SERVICE MANUAL

Matrix-12

ENGINEERING CHANGE ORDER

ECO No.
802

MATRIX-12 PROCESSOR BOARD

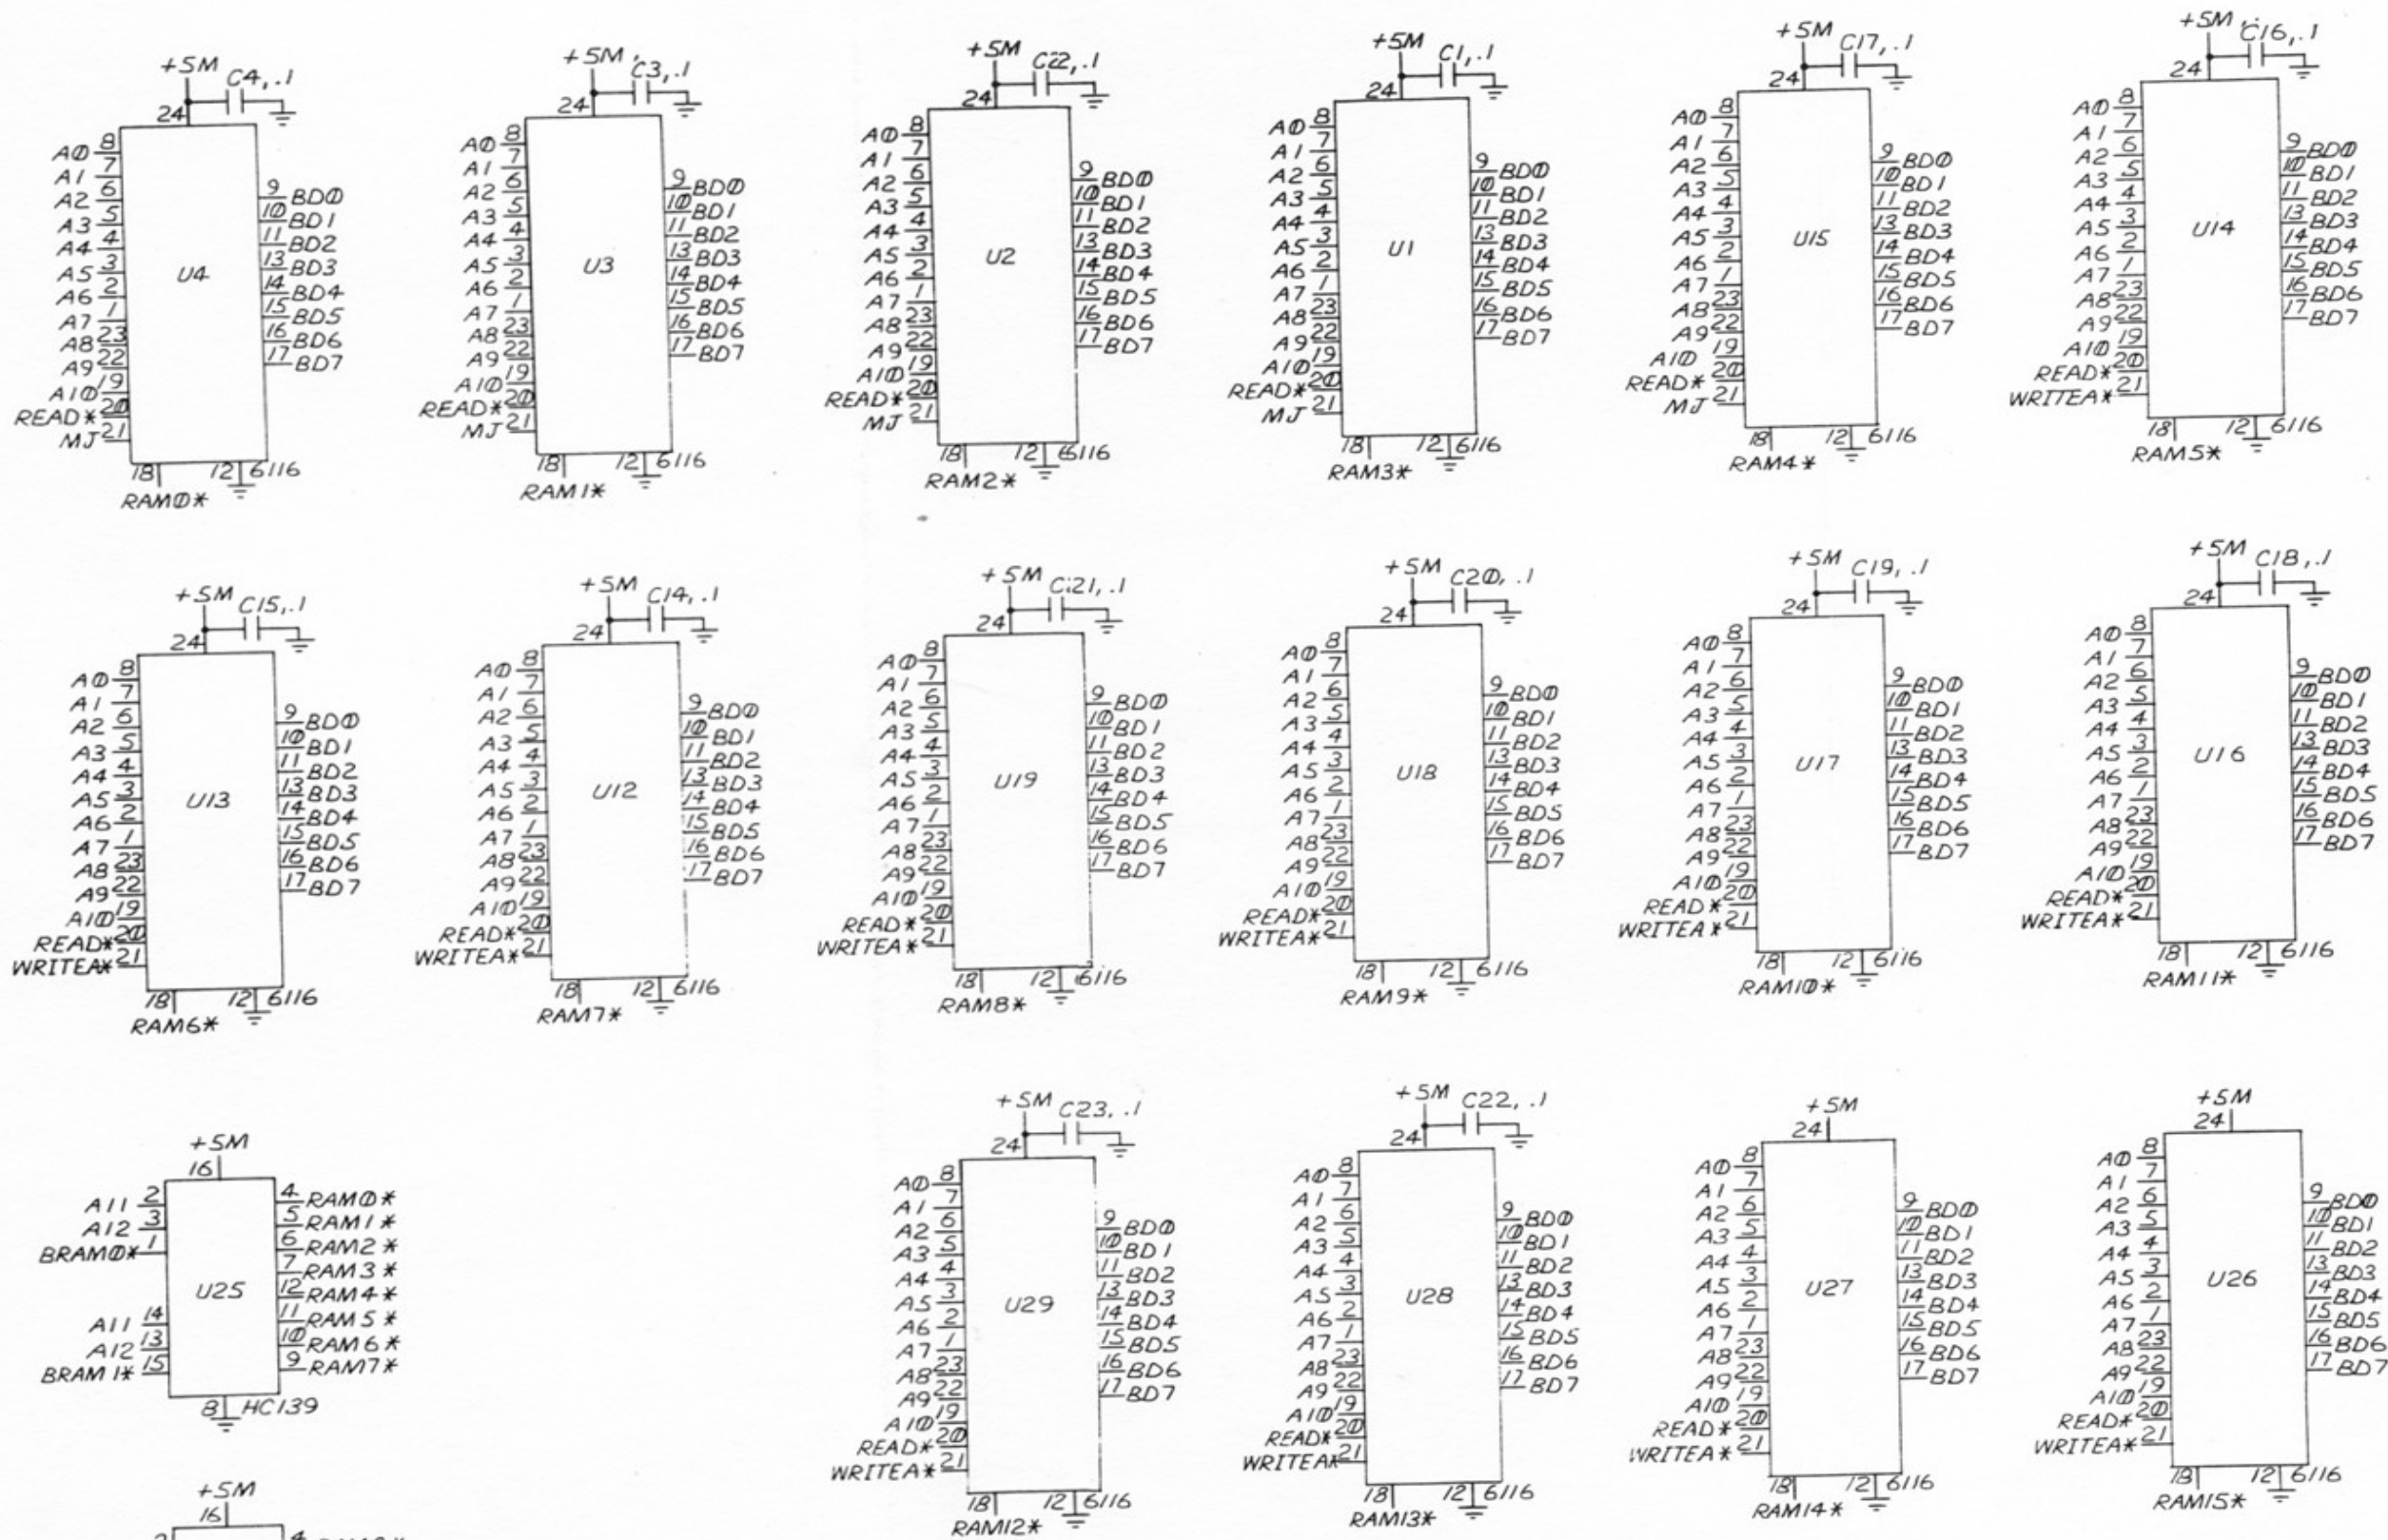
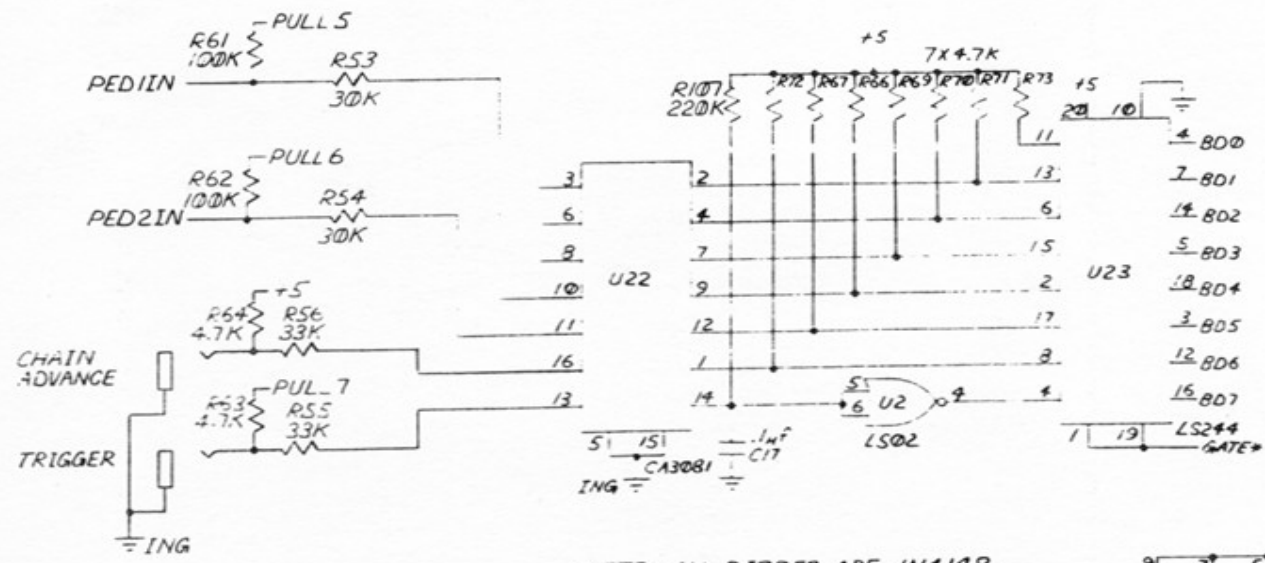
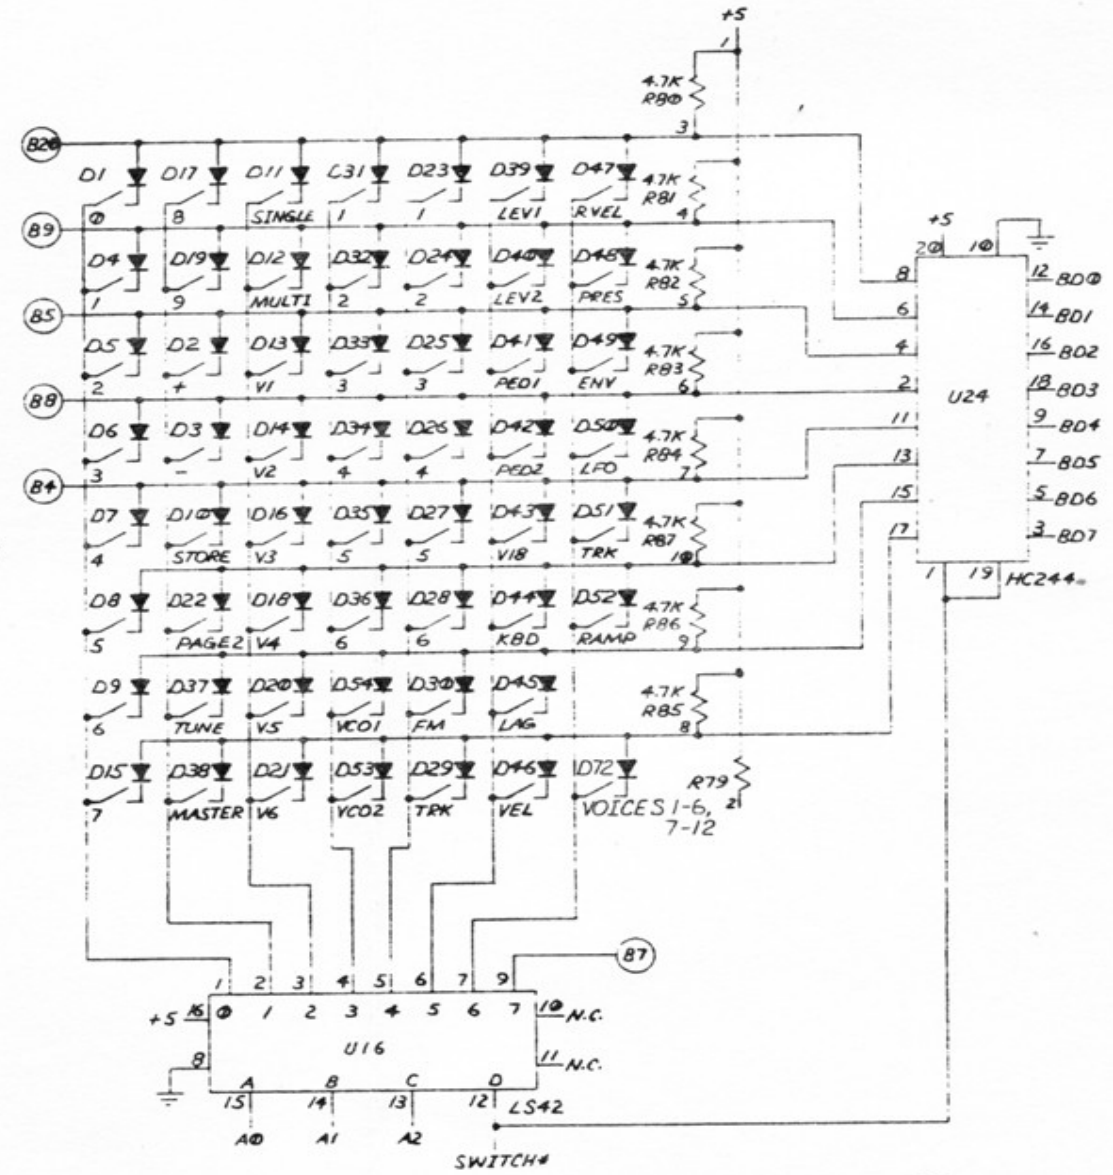
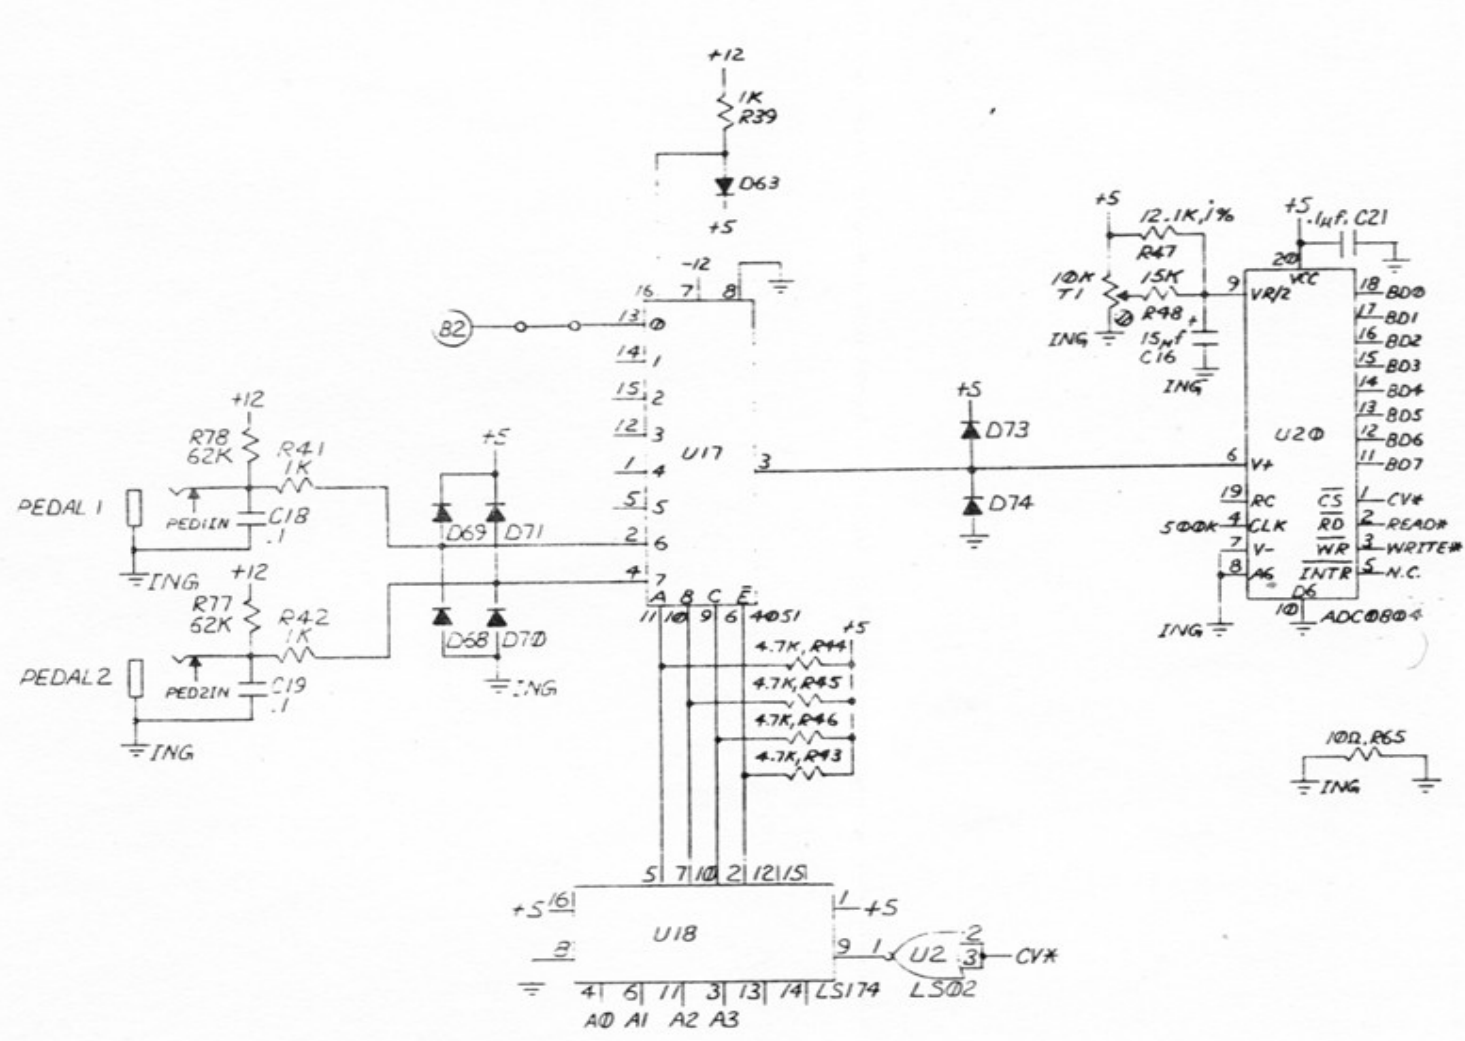
TO ELIMINATE THE POSSIBILITY OF THE CLOCK CABLES BECOMING DISCONNECTED FROM THE PROCESSOR BOARD WHILE IN TRANSIT.

- 1. MODIFY TWO CABLE ASSEMBLIES #4 (OBERHEIM PART #750185-0) BY REMOVING ONE OF THE TWO 3 PIN MOLEX CONNECTORS ON EACH SO THAT THERE IS A CONNECTOR ON ONLY ONE END OF EACH CABLE .**
- 2. REMOVE THE 3 PIN MALE MOLEX CONNECTORS (OBERHEIM PART #219340) ON THE MATRIX-12 PROCESSOR BOARD (720102) AT CONNECTOR LOCATIONS D AND E.**
- 3. SOLDER THE BARE WIRE END OF CABLE ASSEMBLIES TO THE PROCESSOR BOARD AT LOCATIONS D AND E. THE SHIELD OF ONE OF THE CABLES SHOULD BE SOLDERED TO PIN 1 OF CONNECTOR D, AND THE CENTER CONDUCTOR OF THE SAME CABLE SHOULD BE SOLDERED TO PIN 2 OF CONNECTOR D. THE OTHER CABLE SHOULD BE CONNECTED IN THE SAME MANNER TO CONNECTOR E.**
